ADDENDUM NO. 1

RE: Union County Expo Center
El Dorado, Arkansas

ADDENDUM DATE: July 15, 2024

South Arkansas Expo Center Architectural Bid Package Addendum

REDUCED SCOPE
RECEPTION
PLAN

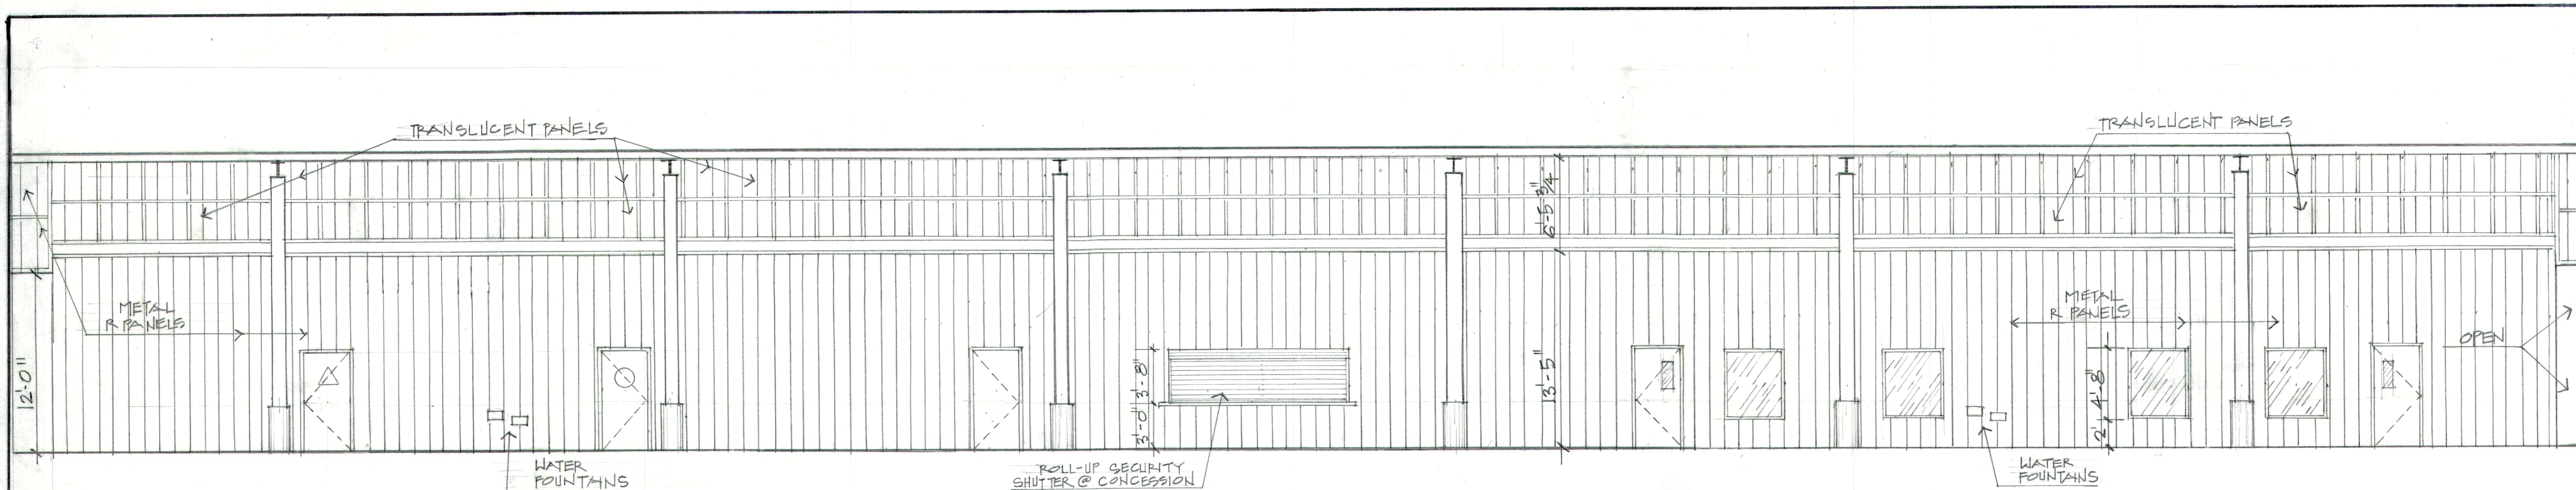
1. **Drawing A-2.22 REDUCED SCOPE RECEPTION PLAN 06.30.2024**
To be bid as an alternate to the larger Reception Center
2. **Drawing A-2.23 REDUCED SCOPE RECEPTION ELEVATIONS 06.30.2024**
To be bid as an alternate to the larger Reception Center

SITE PLAN
A-1.3

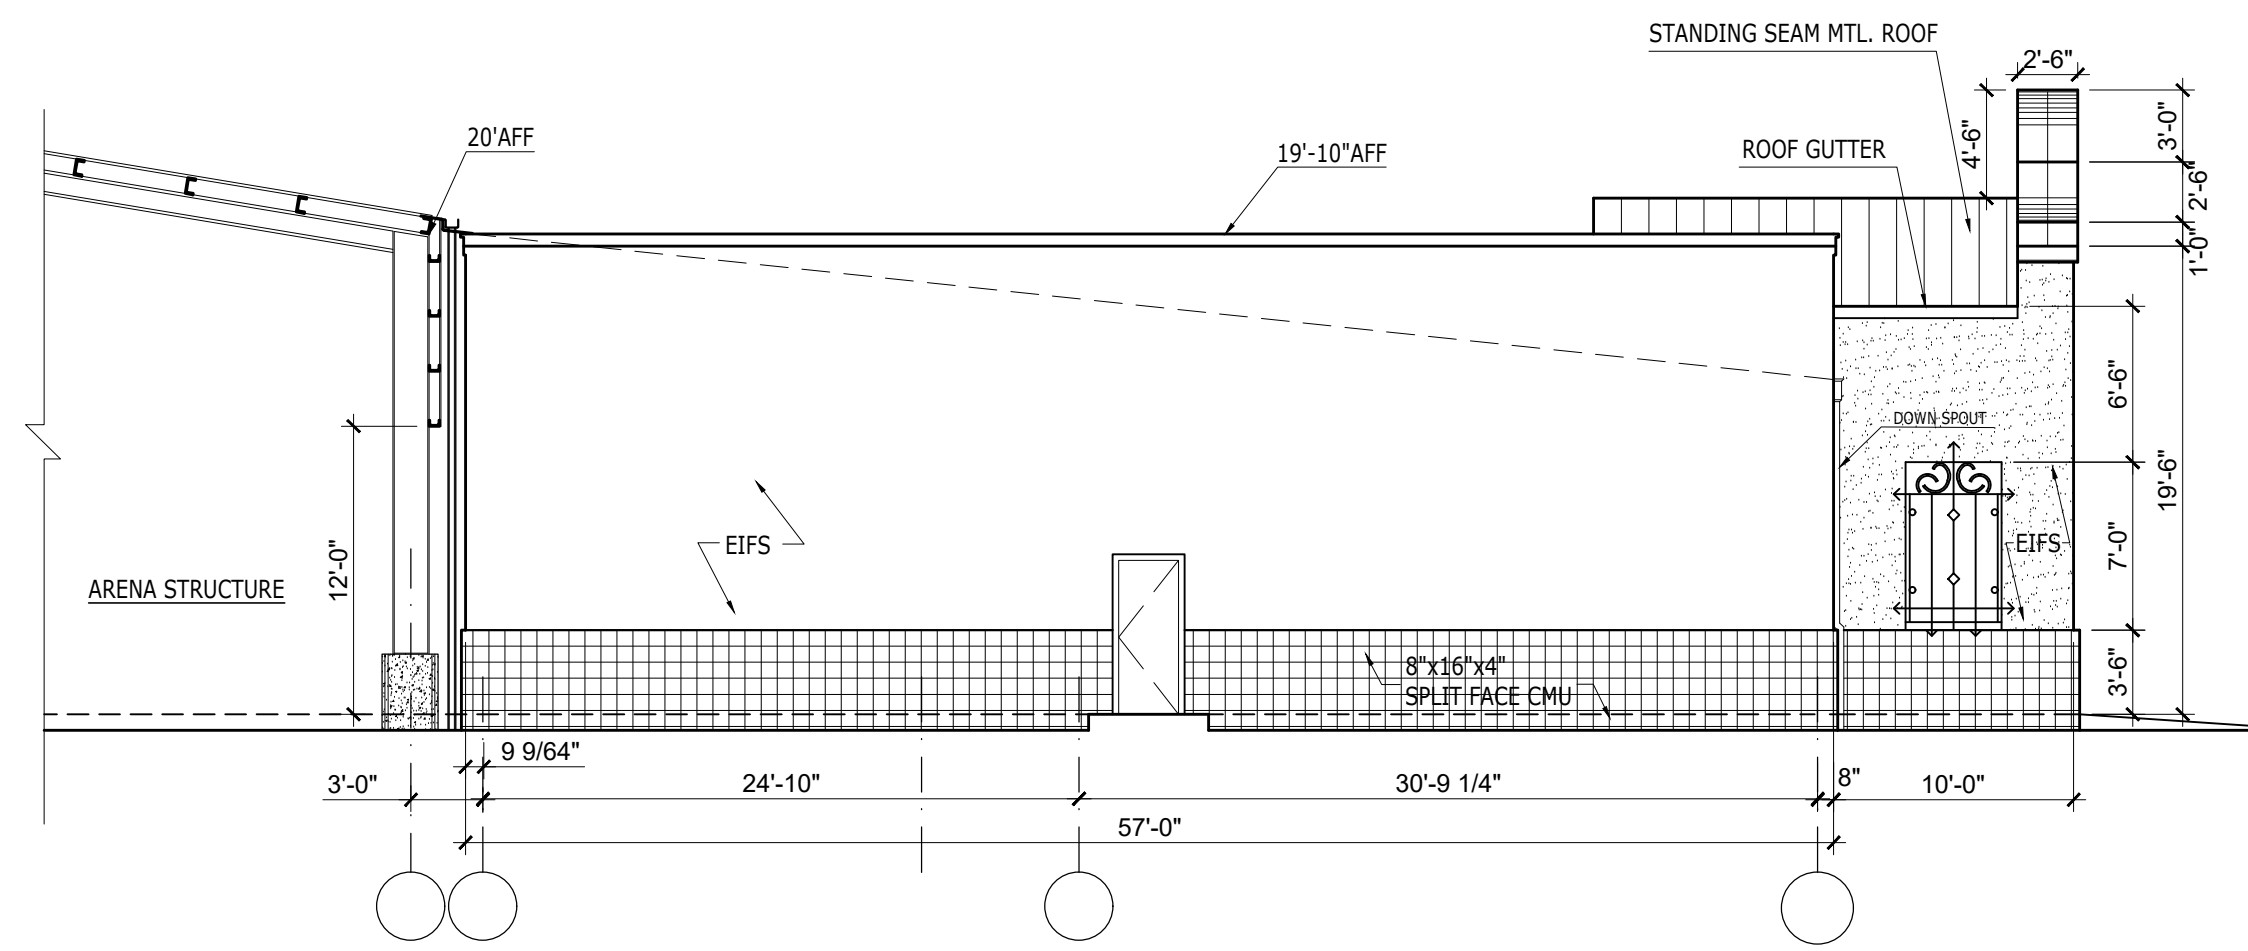
6. **Drawing A-1.3 SITE PLAN 2024.7.12**
Replaces previous A-1.3 SITE PLAN with updated site layout.
7. **Drawing A-3.0 RECEPTION ELEVATIONS 2024.7.12**
Replaces previous A-3.0 RECEPTION ELEVATIONS. No changes, only improved legibility.

ARENA STALLS & CHUTES

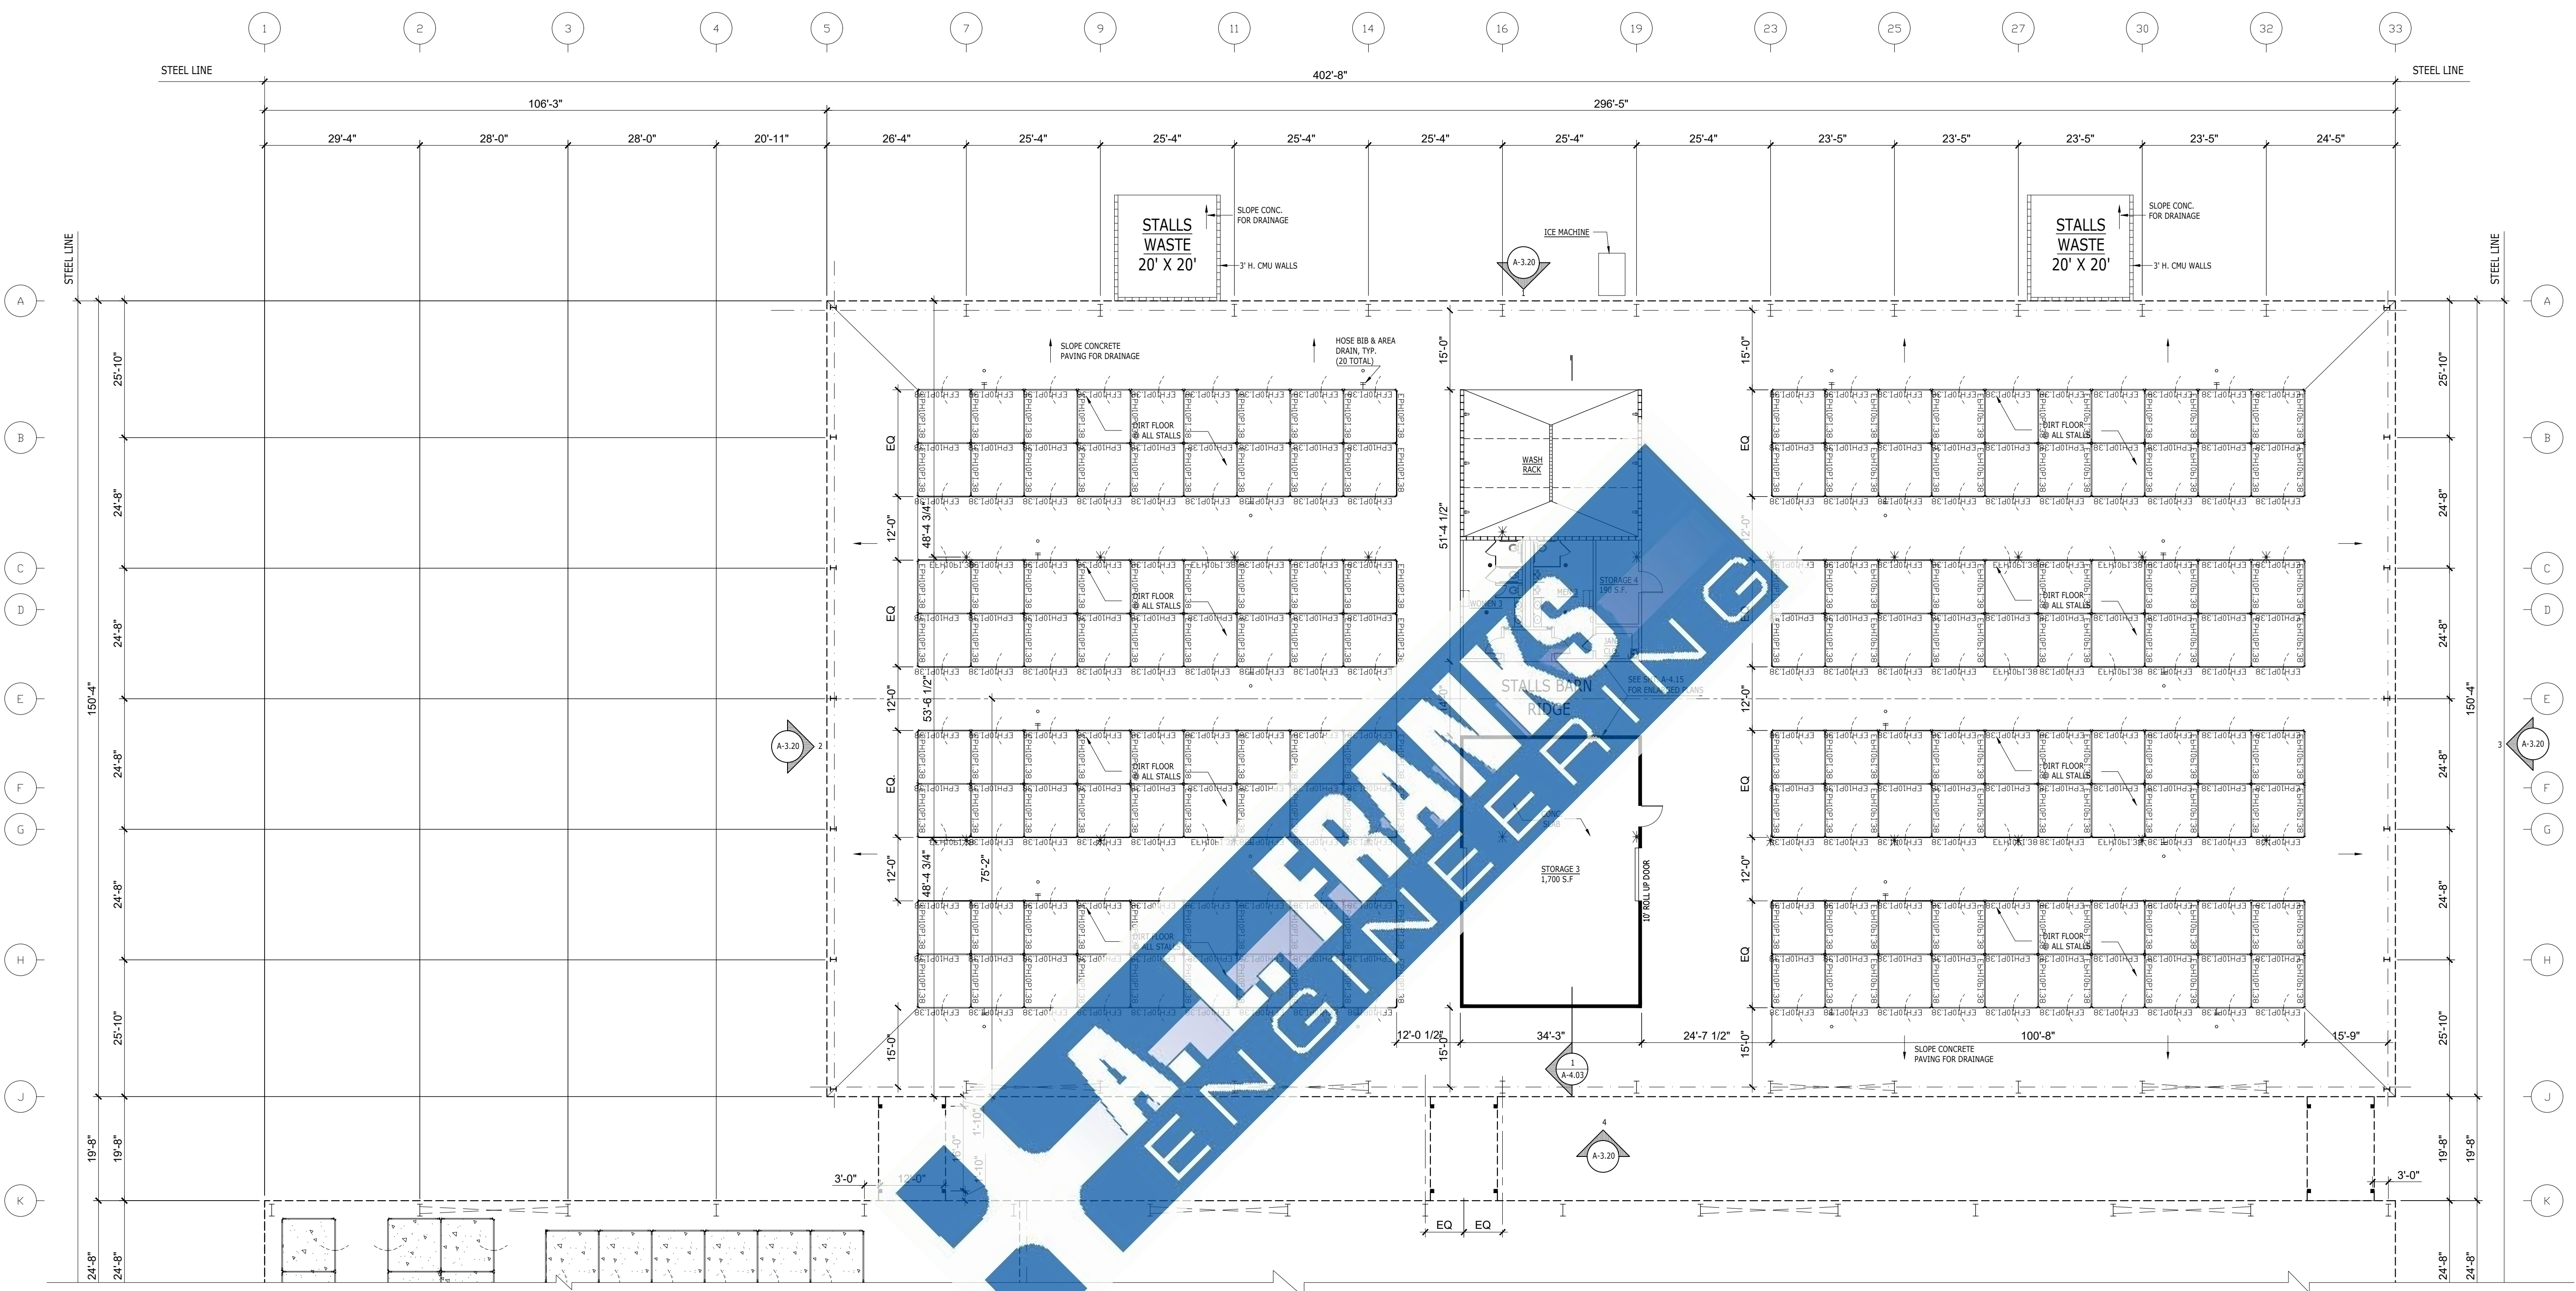
8. **Drawing STALLS.1 07.12.2024**
Provides arena stalls and chutes final layout with specifications of the parts. The chute in the northwest corner is to be brought under the arena roof. Priefert or approved equal.

3. The quantities of light fixtures on the Long Sales quote need confirmation with drawings.
4. The architectural sheet STALLS.1 shows stalls and chutes from Priefert in the arena. Final adjustment is needed to bring the alley on the northwest corner of the arena into the arena structure. Stalls, pens, and chutes are to be provided by Priefert Manufacturing or approved equal. Bryan Northcutt, Phone: 903-434-8919, bnorthcutt@priefert.com

RECEPTION BLDG.
 MECH POWER PLAN

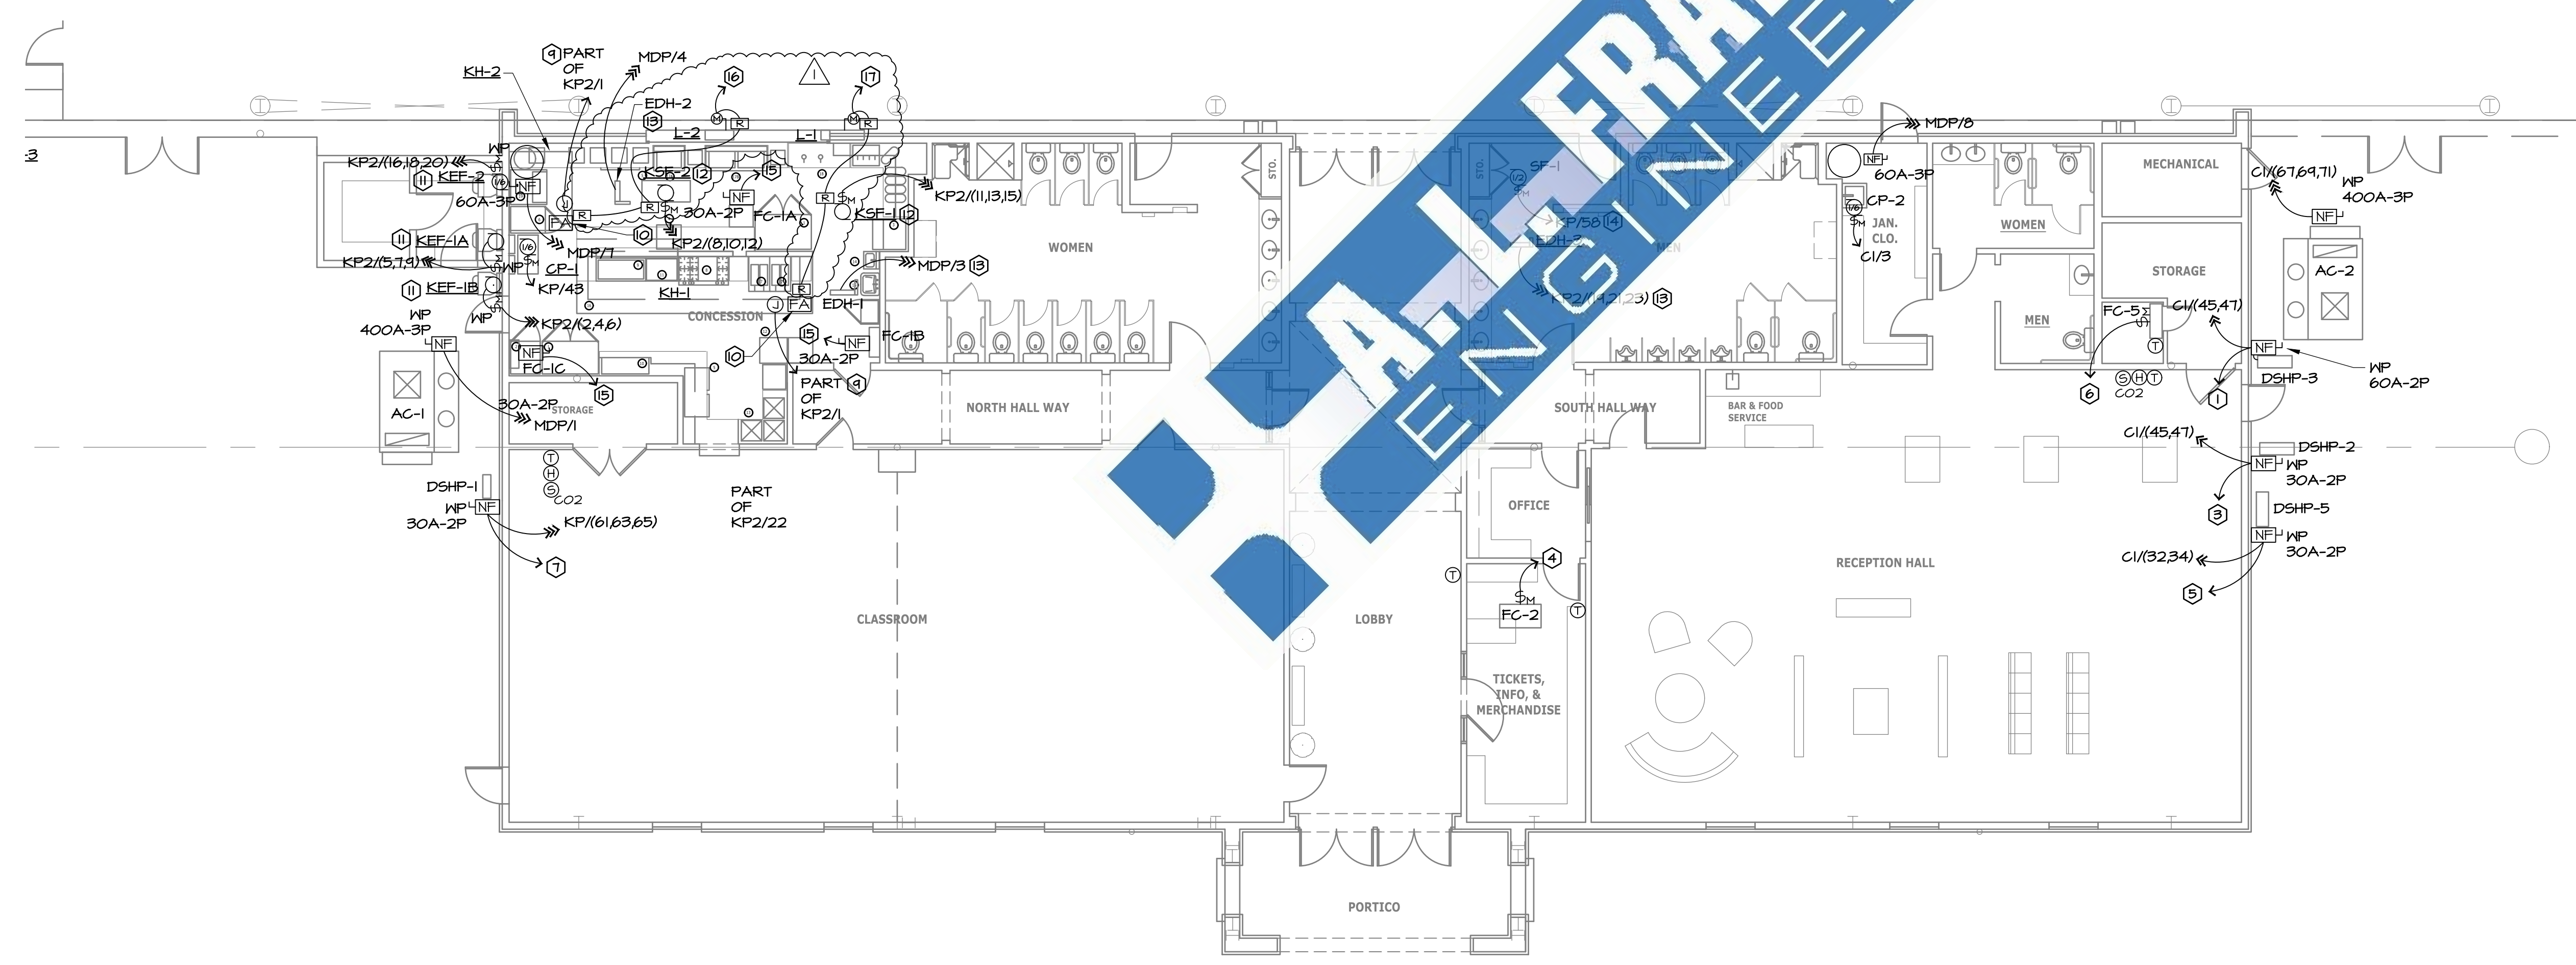
9. **Drawing STALLS.2 07.12.2024**
Provides stalls barn final layout for stalls with specifications of the stalls parts. Priefert or approved equal.
10. **E2.13 7.12.2024** Changes as noted on plans
